JULY 23, 2024

PLANNING COMMISSION MEETING

Review SD-21-03 - 365 Cedar Road Final Major Subdivision Land Development plan.

RE: SD-21-03-365 Cedar Road (Yannessa Subdivision)
PARID: 30-00-07112-00-4 / TMID: 30086 020
Final Major Subdivision and Land Development Plans
Executive Summary

RECORD PLAN OF SUBDIVISION
365 CEDAR ROAD
ABINGTON TOWNSHIP, MONTGOMERY COUNTY, PENNSYLVANIA
MADE FOR
PAUL YANNESSA

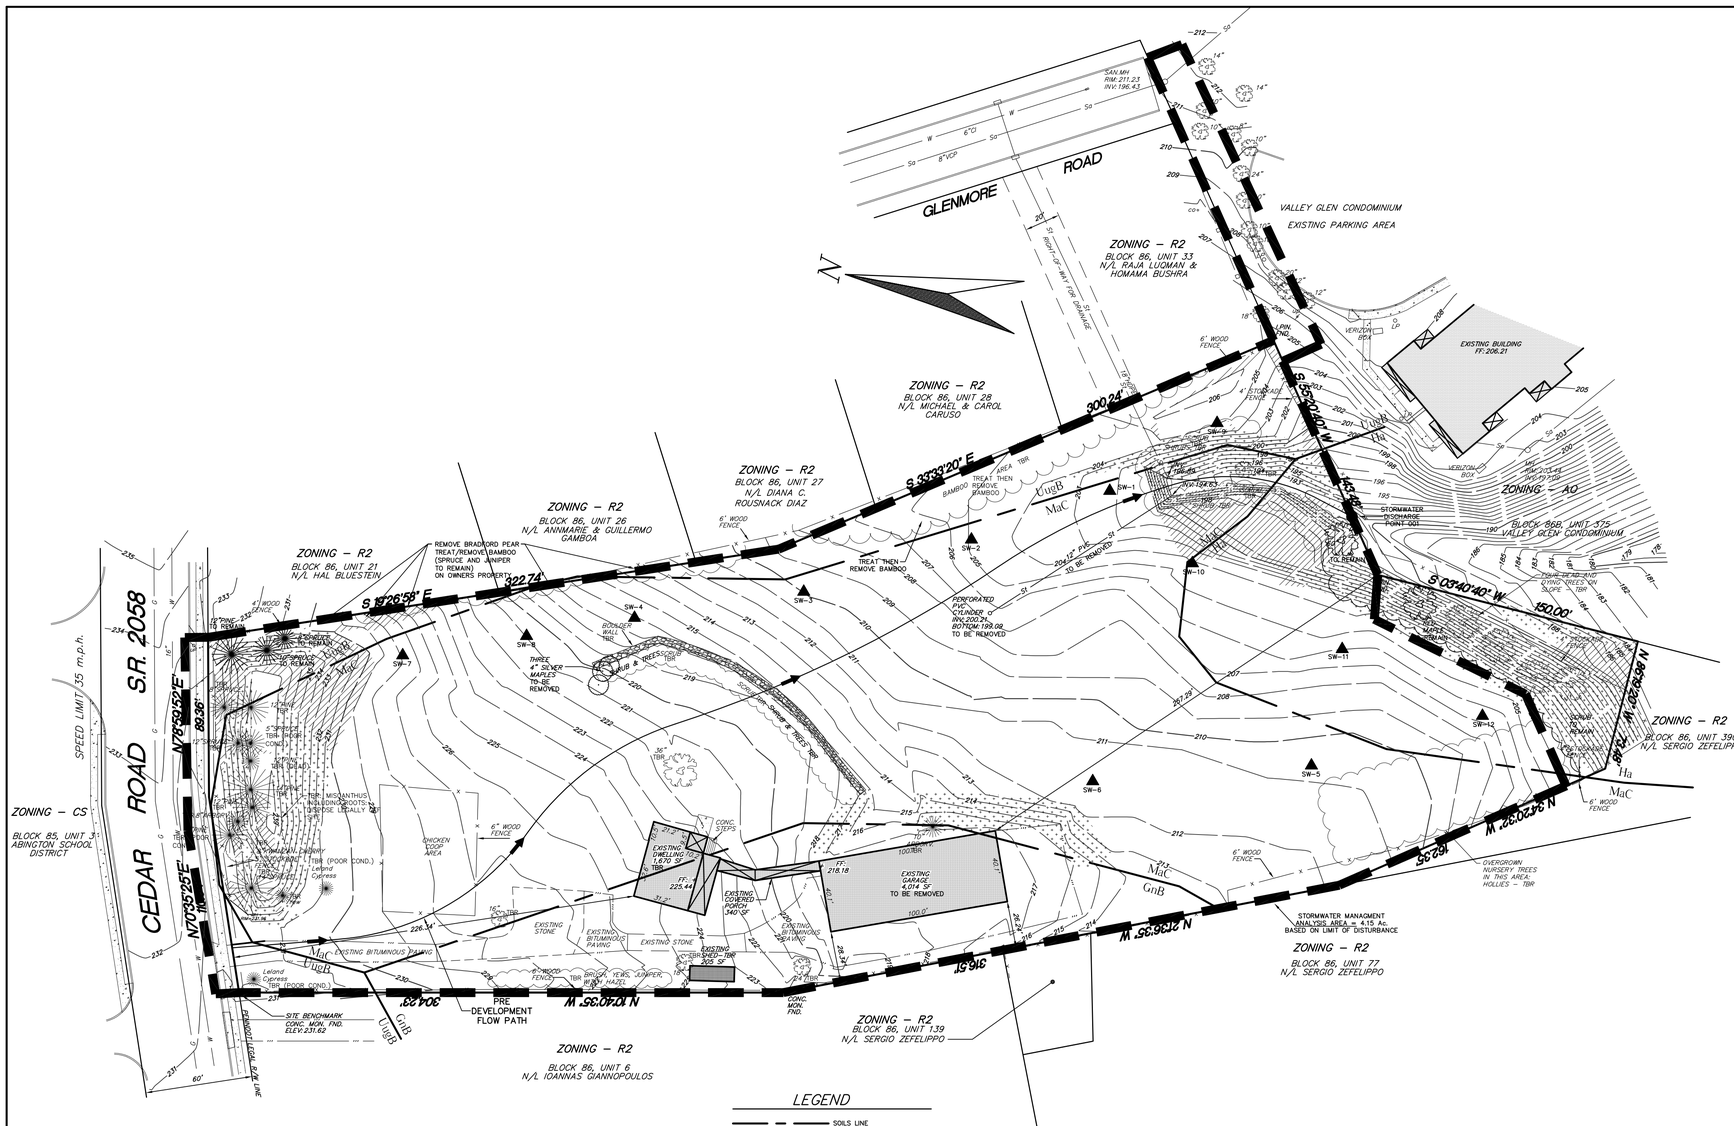
On the Record Plan (Sheet 1), the Permitted Dimensional Criteria Table is providing the 25% maximum building coverage for each lot and the Zoning data listed in Note 4 of the General Notes and Summary is still showing "less than 25%" building coverage being provided. A note was also provided under the Permitted Dimensional Criteria Table stating that the conceptual dwellings, driveways & walkways are shown on the plan, and the actual design & impervious coverage shall be based on final architectural plans & shall be provided on the individual building permit plans for review and approval. Based on our measurements and calculations of the proposed conceptual dwellings, we measured each conceptual dwelling size to be approximately 1,500 SF which will result in less than 10% of the building coverage for each lot which should comply with the required 25% maximum building coverage permitted for each lot; however the Applicant shall clarify and confirm by showing the square footage of each conceptual dwelling and building coverage on the plan for each lot to ensure compliance with this Code Section.

On the Record Plan (Sheet 1), the Permitted Dimensional Criteria Table is providing the 35% maximum impervious coverage for each lot and the Zoning data listed in Note 4 of the General Notes and Summary is still showing "less than 35%" impervious coverage being provided. A note was also provided under the Permitted Dimensional Criteria Table stating that the conceptual dwellings, driveways & walkways are shown on the plan, and the actual design & impervious coverage shall be based on final architectural plans & shall be provided on the individual building permit plans for review and approval. Based on our measurements and calculations of the proposed impervious areas, we measured the impervious coverage to range from approximately 2,200 SF to 2,581 SF which will result in approximately 8% to 10% of the impervious coverage for each lot which should comply with the required 35% maximum impervious coverage permitted for each lot; however, the Applicant shall clarify and confirm by showing the square footage of the impervious coverage on the plan for each lot to ensure compliance with this Code Section.

On the Record Plan (Sheet 1), the Permitted Dimensional Criteria Table is providing the 65% minimum green area for each lot and the Zoning data listed in Note 4 of the General Notes and Summary is still showing "more than 65%" green area being provided. Based on our measurements and calculations of the proposed impervious areas for each lot as noted above, the resulting green area for each lot ranging from at 84% to 92% should comply with the required 65% minimum green area for each lot; however, the Applicant shall clarify and confirm by showing the green area percentage on the plan for each lot to ensure compliance with this Code Section.

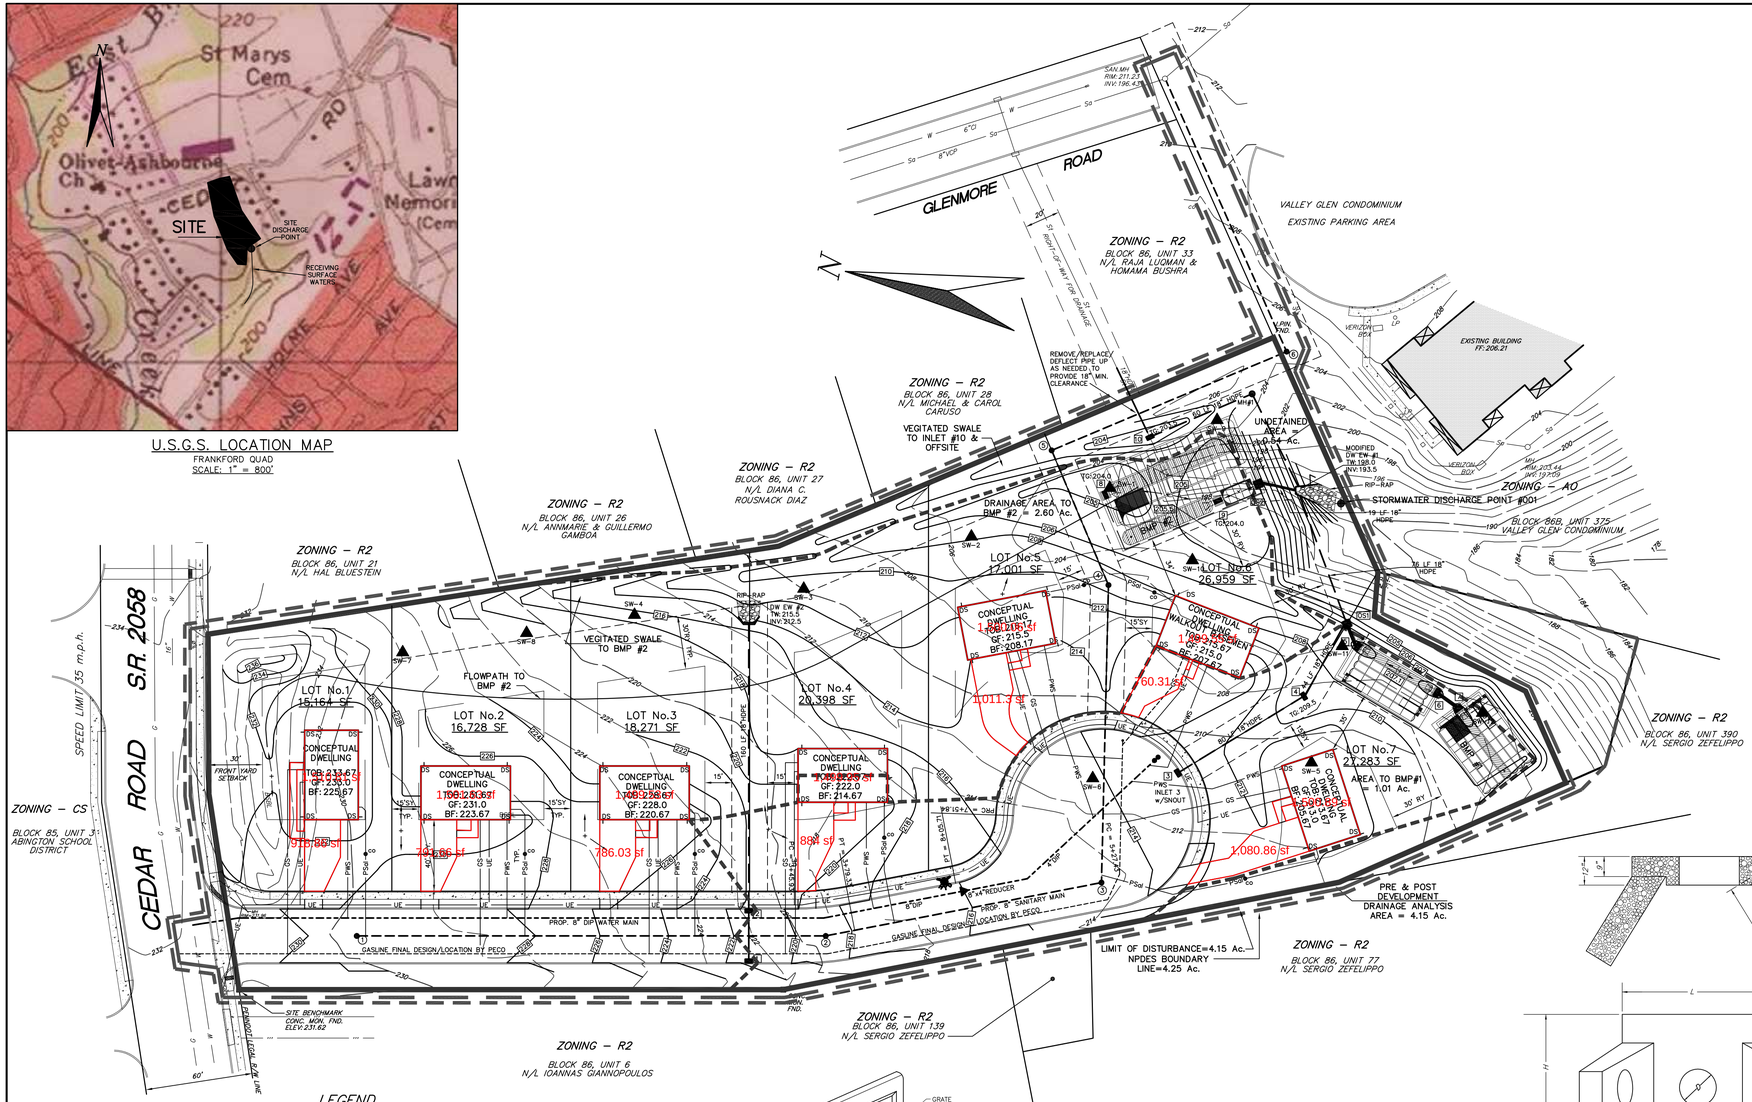
The municipal engineer certification block on the PCSM Plan (Sheet 7) shall reference Municipal Ordinance no. 2100 instead of Chapter 142.

33. *The Raingarden Section Detail on Sheet 7 shall provide the 100-year storm water elevation which is currently not shown on the detail provided.*
